**STATE OF HAWAII
DEPARTMENT OF TRANSPORTATION
AIRPORTS**

**ADDENDUM NO. 1
FOR
CBP FIS RENOVATION
DANIEL K. INOUE INTERNATIONAL AIRPORT
HONOLULU, OAHU, HAWAII
STATE PROJECT NO. CO1433-33**

August 13, 2026

FURNITURE &
EQUIPMENT PLAN
AND FURNITURE
SCHEDULE

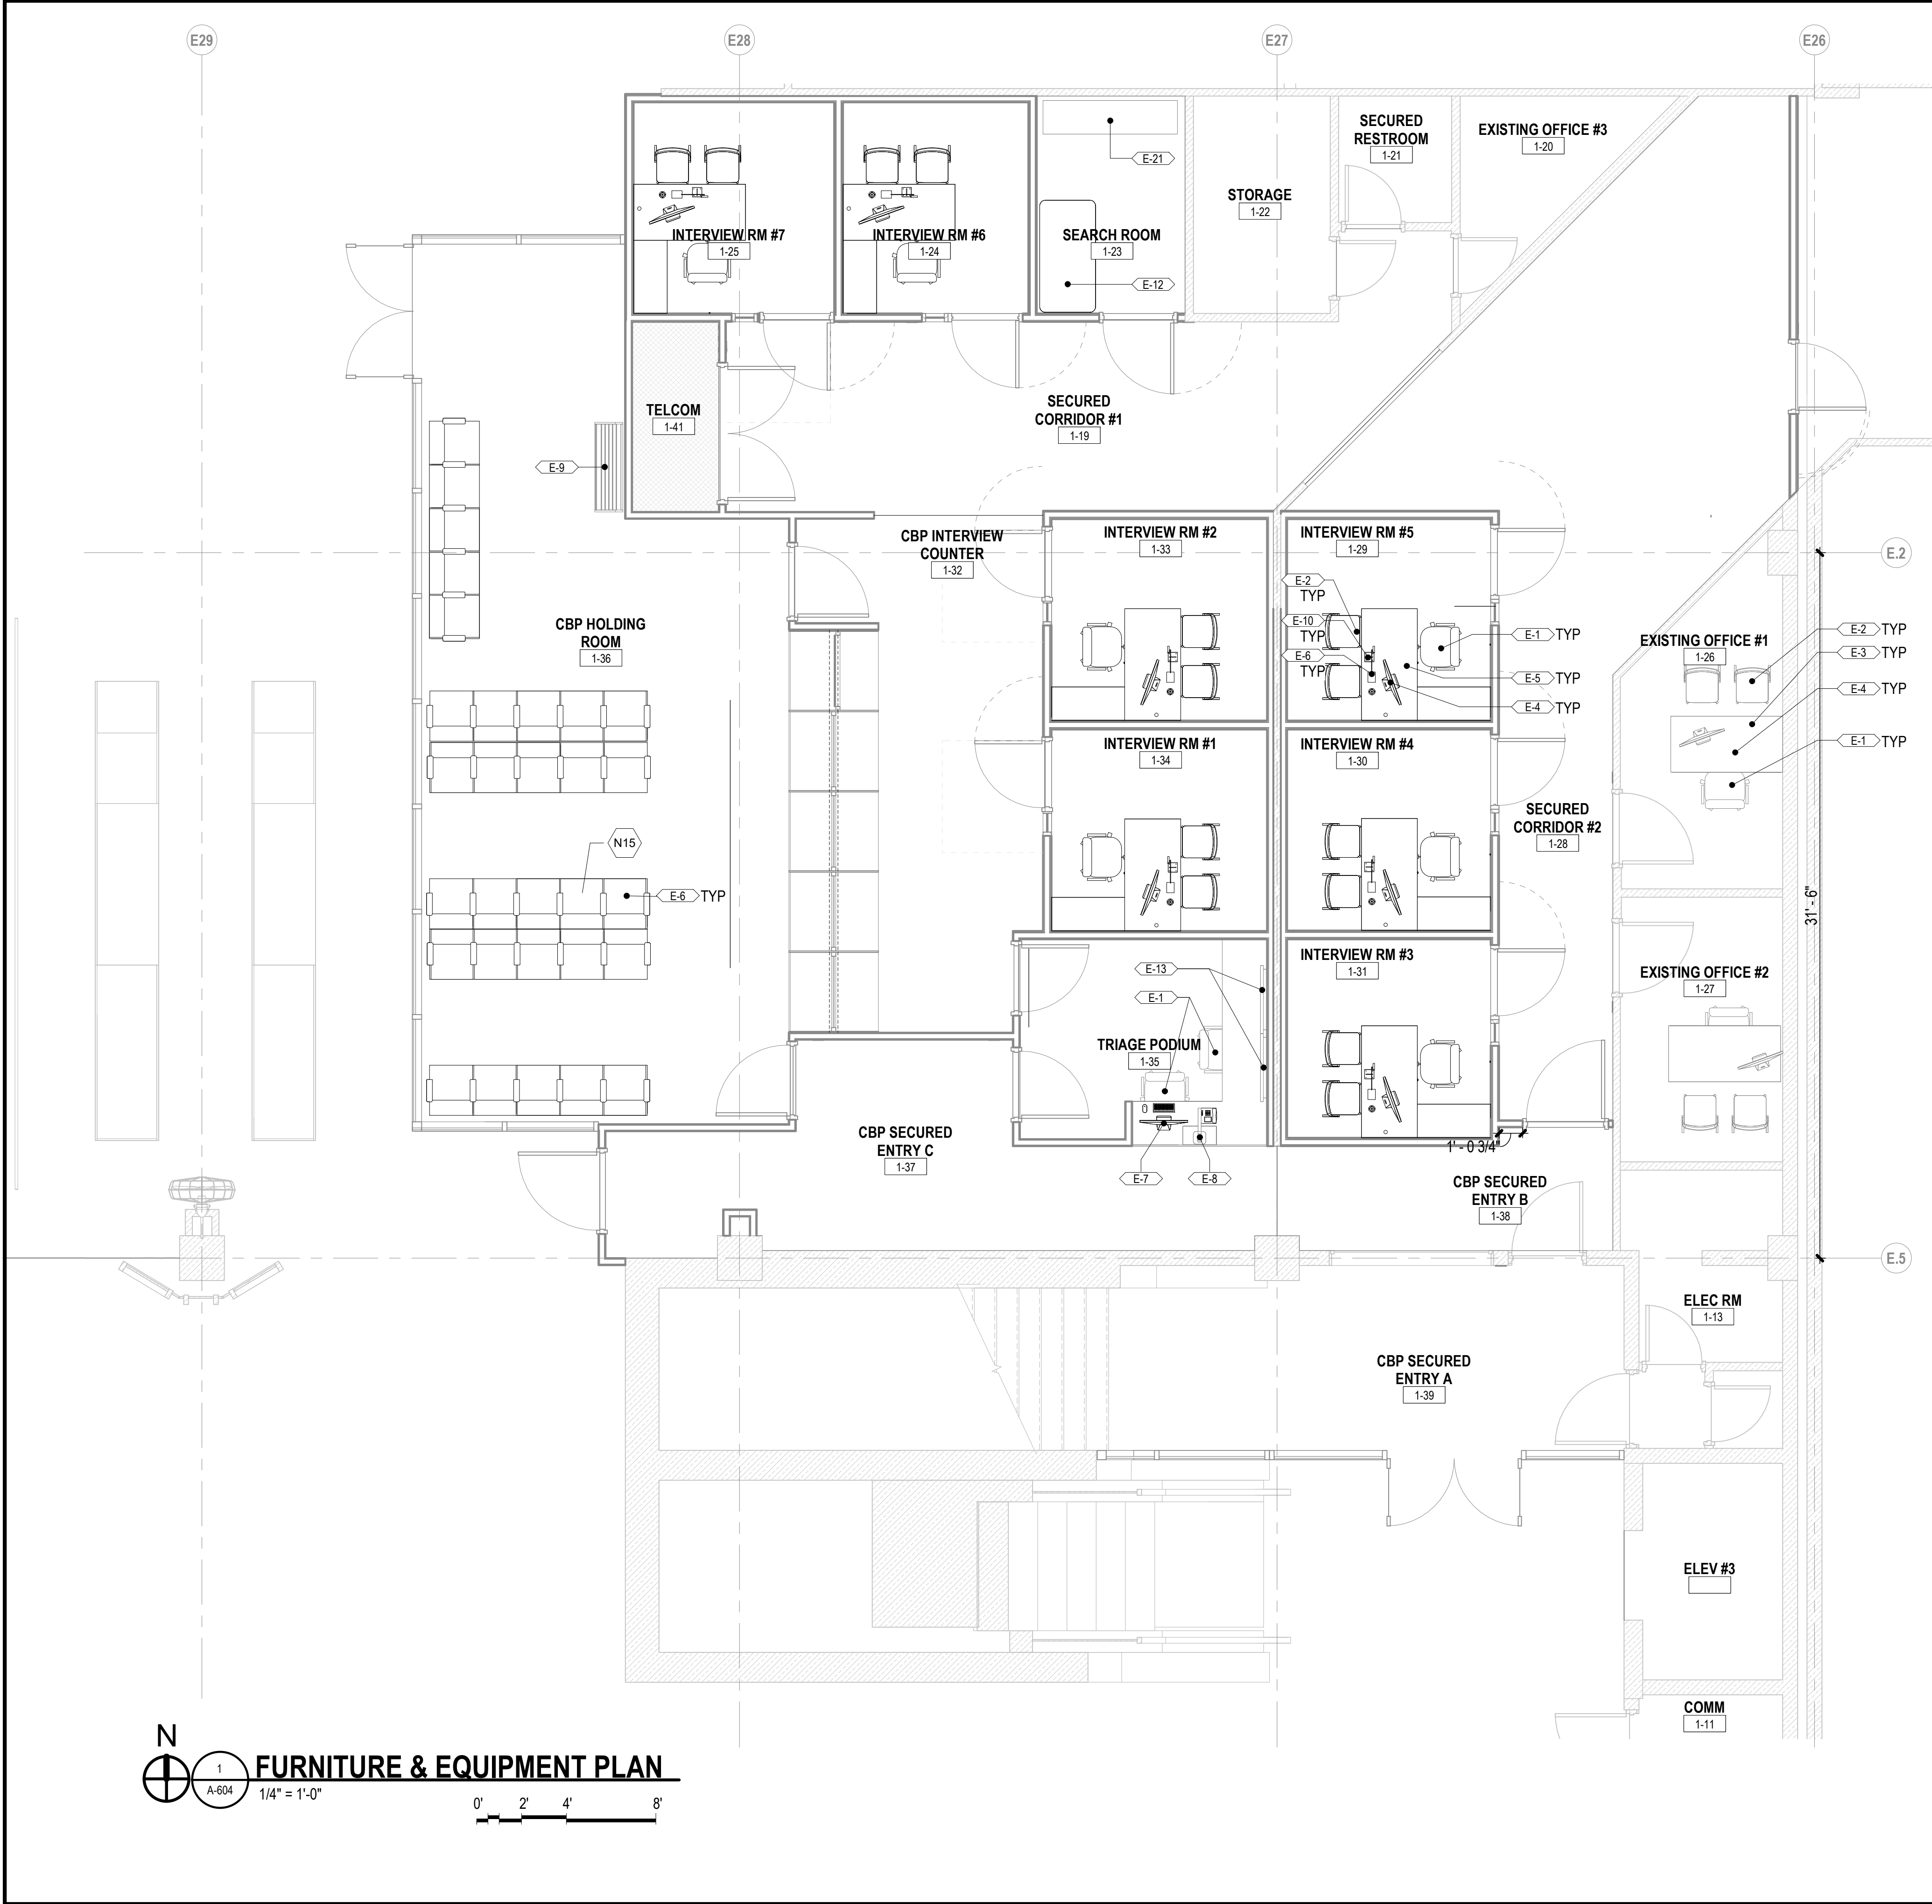
1. **QUESTION:** This question pertains to the # 01210-3 Furniture portion - can we omit the following CODES E-4, E6-10, E13 & E14 from our pricing? No specification on these items. Please advise

ANSWER: No. See revised finish schedule on attached A-sheets.
